# UNITED STATES PATENT AND TRADEMARK OFFICE

APPLICATION NO.	FILING DATE	FIRST NAMED INVENTOR	ATTORNEY DOCKET NO.	CONFIRMATION NO.
10/511,906	10/20/2004	Motohide Murayama	260429US3PCT	4215
22850 7590 08/08/2007 OBLON, SPIVAK, MCCLELLAND, MAIER & NEUSTADT, P.C. 1940 DUKE STREET ALEXANDRIA, VA 22314			EXAMINER RODRIGUEZ, WILLIAM H	
			ART UNIT 3746	PAPER NUMBER
			NOTIFICATION DATE 08/08/2007	DELIVERY MODE ELECTRONIC

## Office Action Summary

### **DETAILED ACTION**

**FIG. 8**

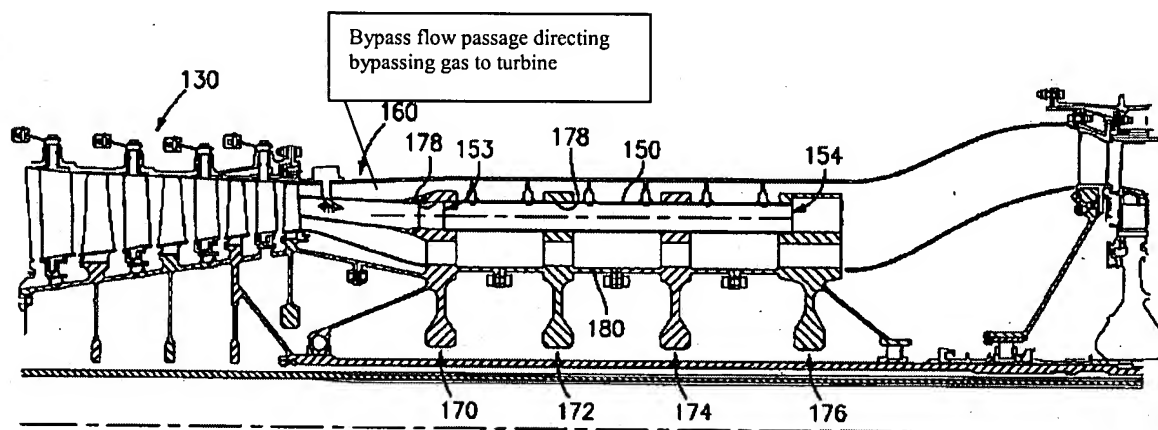
Nordeen (particularly Figures 5 and 8) teaches a pulse detonation engine comprising: a gas supply section (compressed air from compressor 130), a fuel supply section 190, a detonation generator section including a detonation tube 150, an igniter 32 for igniting the mixture of gas and fuel in the detonation tube, a turbine section 136 driven by impact energies of detonations, the detonation generator section including a shock alleviating section 134, said turbine section including a first turbine (high pressure turbine) and a second turbine (a low pressure turbine) mounted on a common shaft, said common shaft being rotated by motive power converted from drive force generated by the turbine, and a bypass flow passage for bypassing a portion of said gas to the turbine (cl. 3 ll. 49-52), wherein said turbine rotation can be used to generate electric power to drive accessory equipment of said gas turbine.

With regards to the method claims, since Nordeen has the same structure as claimed, it is inherent that Nordeen's device would be able to perform the recited method steps.
